Submission supporting a new metro rail line between Chatswood and Sydenham

I submit the following responses to the Environmental Impact Statement (EIS) produced by Transport for NSW Sydney Metro Delivery Office:

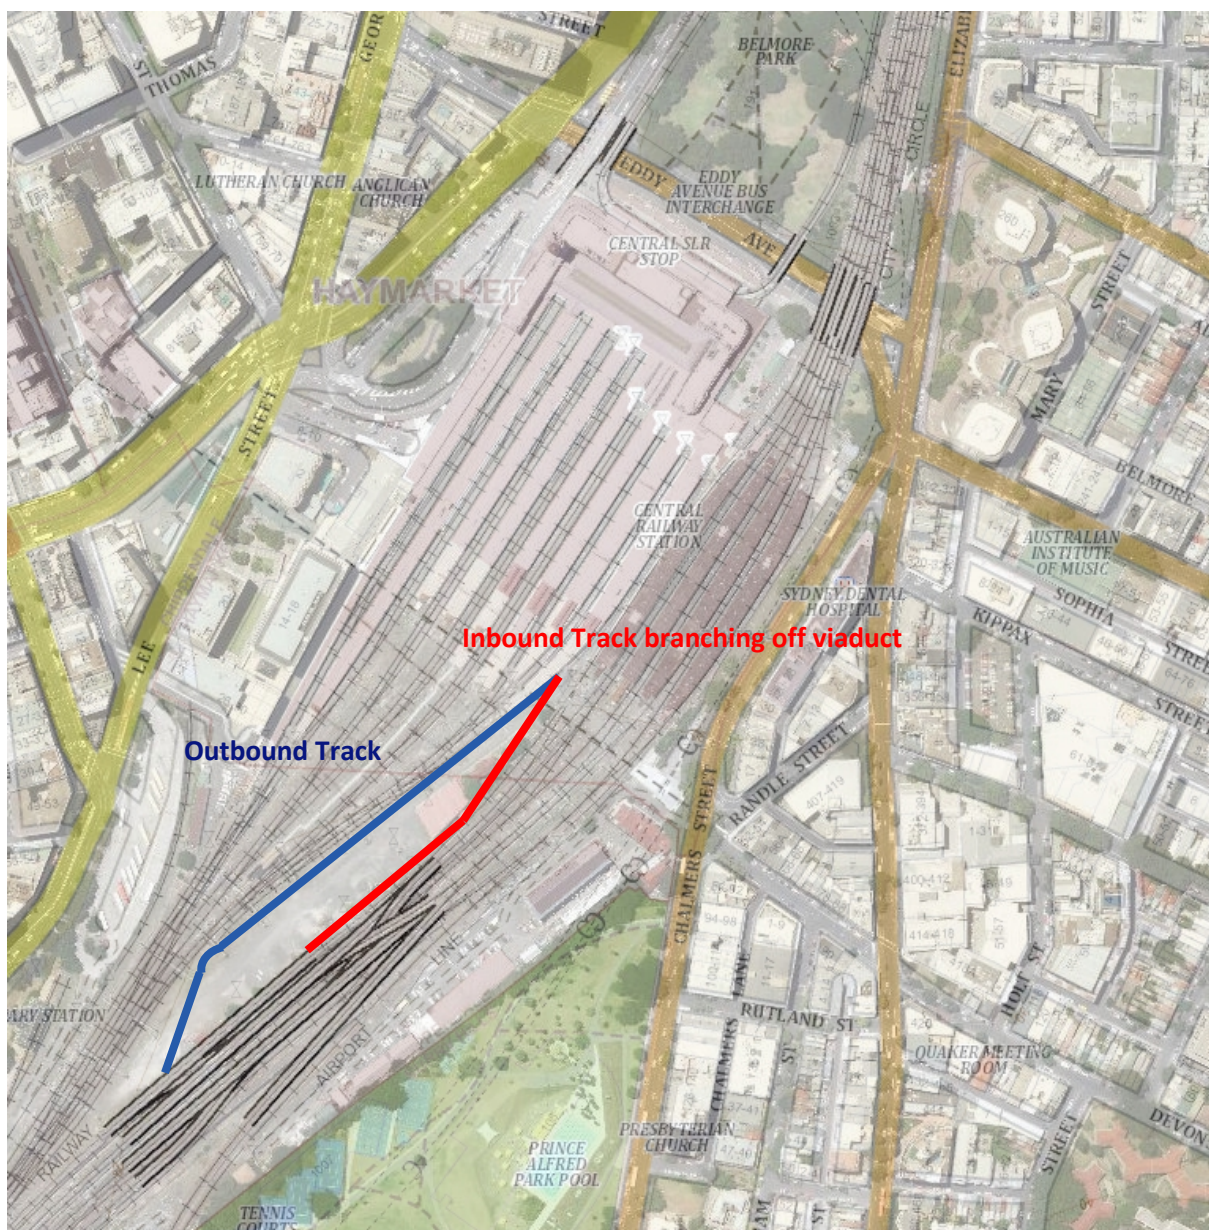
The proposal to integrate Platform 15 as a terminating suburban platform is supported. This needs to operate as an effective turnback point for outer suburban trains while permitting brief headways between train arrivals. The platform would ideally therefore connect to the suburban rail tracks, rather than the congestion-prone array of bifurcating intercity tracks that invariably impair train speeds in both directions between the Cleveland Street underpass and the terminal at Central.

Works in the Sydney Yard area of Central are required under this project. It would be most practical to incorporate new rail track connections for the rebuilt Platform 15 around the margins of this yard alongside the metro construction program. A rough visual representation of the connectivity being suggested is shown below.

Platforms 13-15 should be reinstated with sufficient length to accommodate 10 carriage train arrays, as may be required in the future for some outer suburban Sydney Trains services to meet patronage growth.
